Administrative Approval Action

AA # 3953 / SR-70-18, 3020 Hillsborough Revision
Transaction# 590870

REQUEST: **THIS IS A REVISION TO THE PREVIOUS APPROVED SITE PLAN (#564111)**
Development of a combination of nine parcels totaling 2.397 acres, zoned NX-3-UG, OX-3-DE, and R6, and all within an SRPOD Overlay, into a 226,806 gross square foot mixed use project consisting of retail and residential uses (132 dwelling units). All lots are to be recombined into one parcel. The revision is related to a shift in the shared property line on the north side of the site and includes a reduction in approved gross building space and one fewer residential unit.

3020 HILLSBOROUGH PROPOSED BUILDING

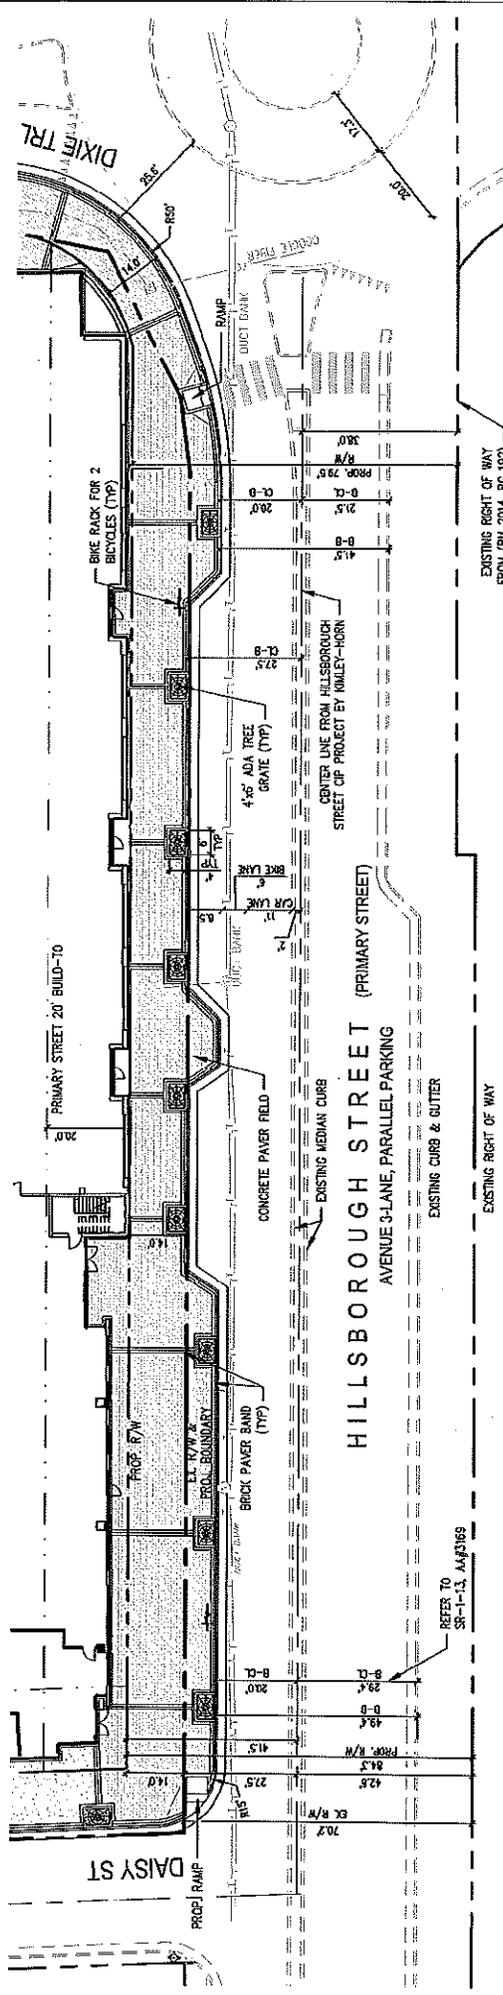
1. Hillsborough Street is a 3 Lane, Parallel Parking street type (UDO section 8.4.5 C.) The UDO required ROW for the existing street is 90'. In 2017 The City completed the street and streetscape improvements from the City Council approved Hillsborough Street Revitalization project. The project varied from the travel lanes in that a 4' median was constructed along the frontage in lieu of a 11' center turn lane. It is not anticipated that the median would be removed for a center turn lane due to the long range plan for the street in place. The developer has shown that their portion of the required travel lane width, bike lanes, parallel parking, streetscape and sidewalk width can be provided within 1/2 of an 83' ROW.

2. The proposed plan meets the required streetscape required of the zoning frontage while maintaining the street section associated with the Hillsborough Street Revitalization project.

1. Due to the existing median relief from the required right of way dedication is granted. (UDO Section 8.5) (DA-95-2018)
